ORIGINATION FORM

Proposed Revisions to a Standard Plans Index

Index Number: 700-041

Index Title: Span Sign Structure

LAST REVISION	DESCRIPTION:	FY 2022-23 STANDARD PLANS	SPAN SIGN STRUCTURE	INDEX	SHEET
11/01/19	11/01/22	FDOT		700-041	1 of 5

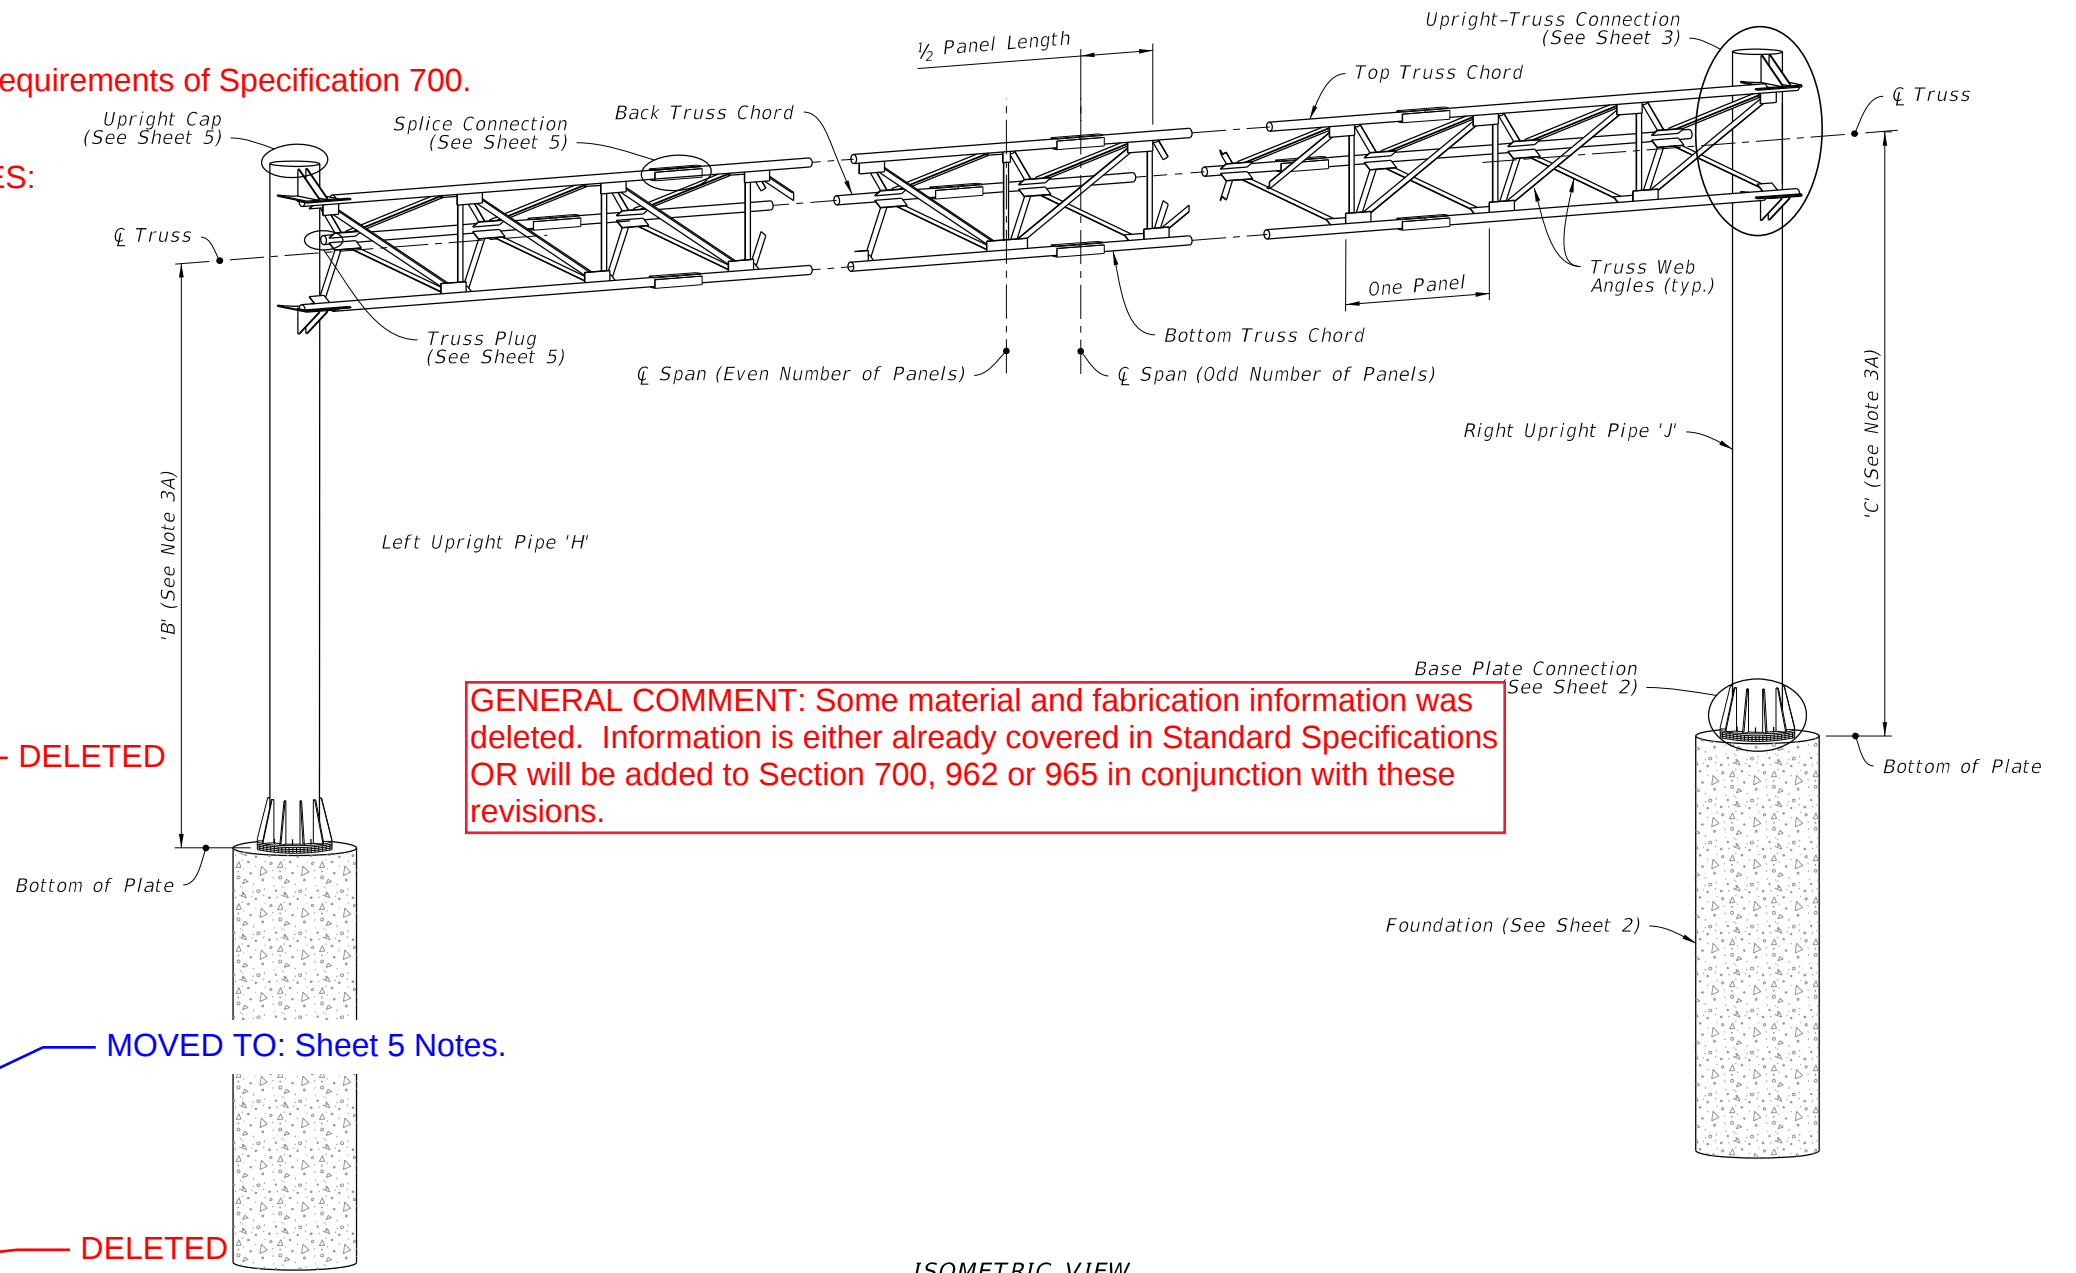
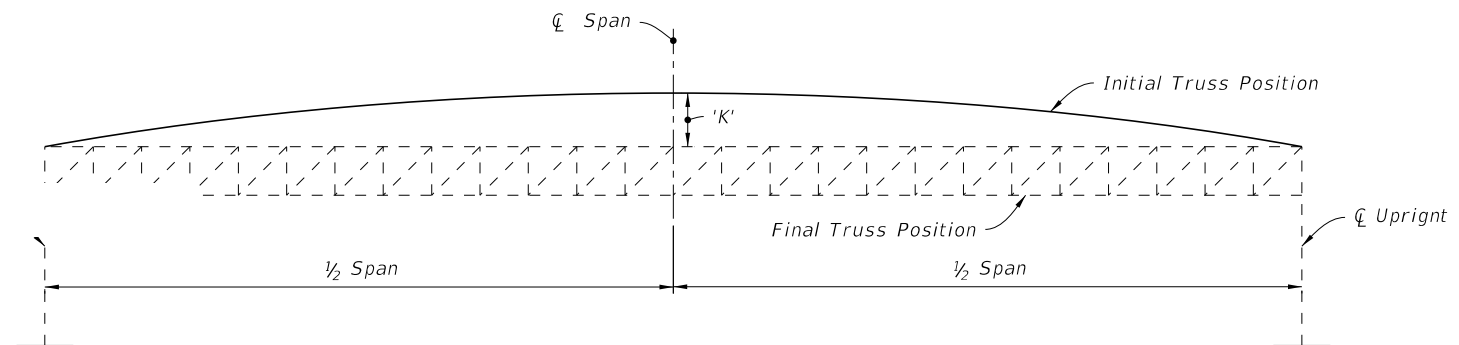
Sheet 1: Updated Notes to General Notes; Added New General Note 1 - "Meet the requirements of Specification 700"; Deleted Notes 4 through 7; Moved Note 5.B and 5.C to Sheet 5 Notes; Renumbered Notes.

ADDED NEW NOTE 1: Meet the requirements of Specification 700.

UPDATED: GENERAL NOTES:

DELETED

MOVED TO: Sheet 5 Notes.

DELETED

DELETED

BASE PLATE CONNECTION

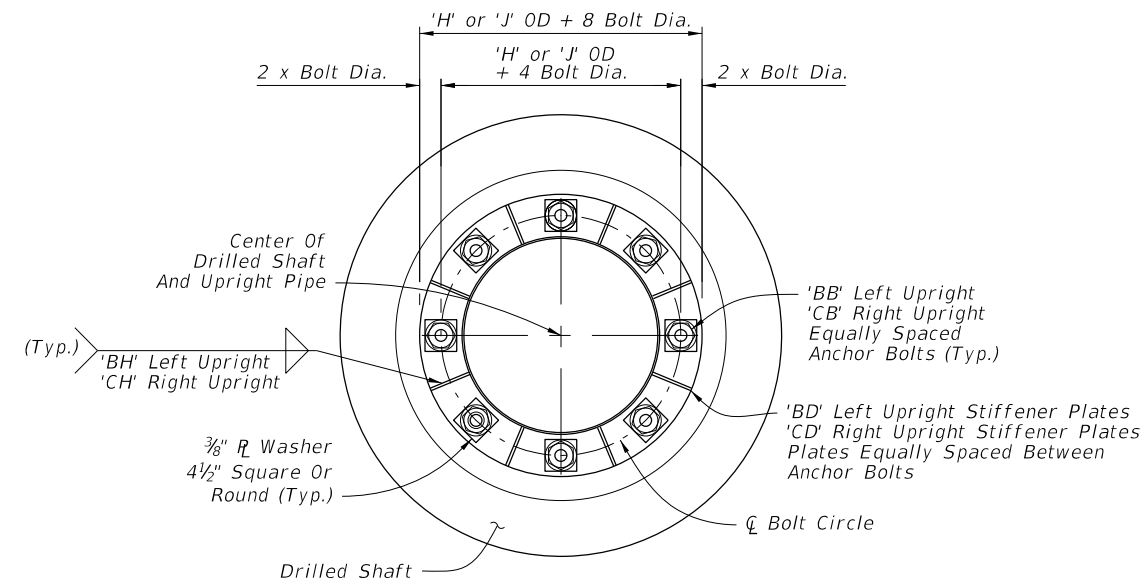
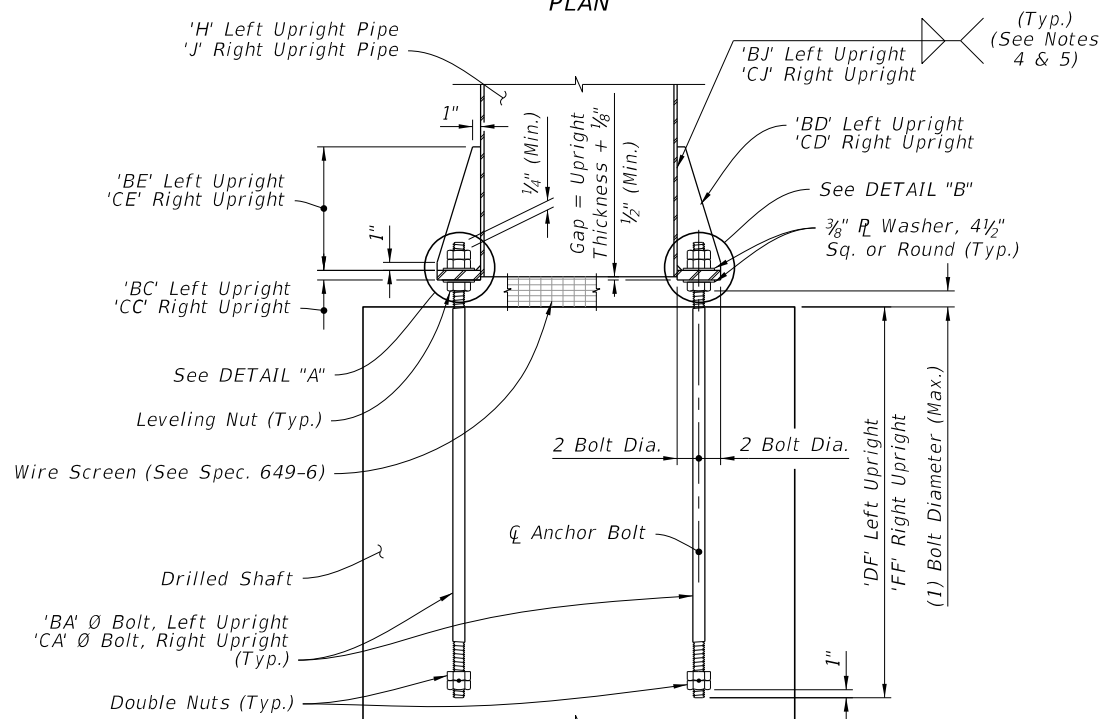
Sheet 2: Added note 6 detailing the weld pattern of the 'BD' and 'CD' plates indicating that they should be welded in a star pattern.

Sheet 2: This process is to help prevent residual stress buildup in base plate connection to prevent cracking.

ADDED NOTE 6: 6. Weld plates 'BD' and 'CD' in a star pattern. A star pattern is one in which the plates on opposite and near opposite sides of the pole circle are successively welded in a pattern resembling a star. For an 8 plate circle with plates sequentially numbered 1 to 8, weld the plates in the following order: (1, 5, 7, 3, 8, 4, 6, 2).

SPLICE CONNECTION NOTE:

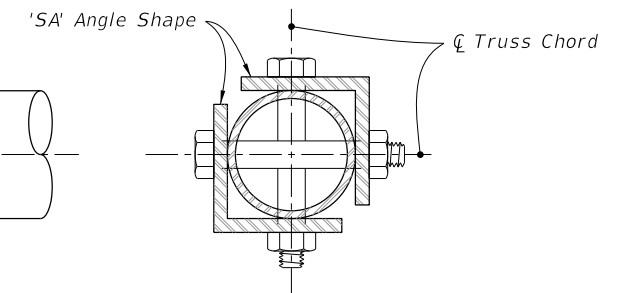
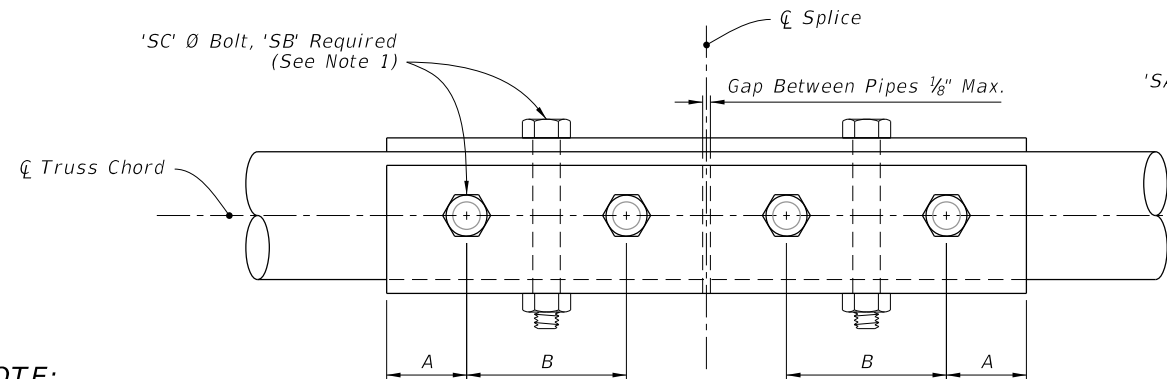
Sheet 5: Added General Note 5.B and 5.C as New Note 2 - "Chord Splices: Minimum splice spacing is three truss panel lengths apart and three truss panel lengths from the uprights when panel lengths are 10'-0" or less. Chord Splices may be either the Standard Splice or the Alternate Splice, but not both on the same structure." and Note 3 - "Upright splice: Not allowed unless the upright exceeds available mill lengths (35' - 40')."

ADDED NOTES 2 AND 3:

2. Chord Splices: Minimum splice spacing is three truss panel lengths apart and three truss panel lengths from the uprights when panel lengths are 10'-0" or less. Chord Splices may be either the Standard Splice or the Alternate Splice, but not both on the same structure.

3. Upright splice: Not allowed unless the upright exceeds available mill lengths (35' - 40').
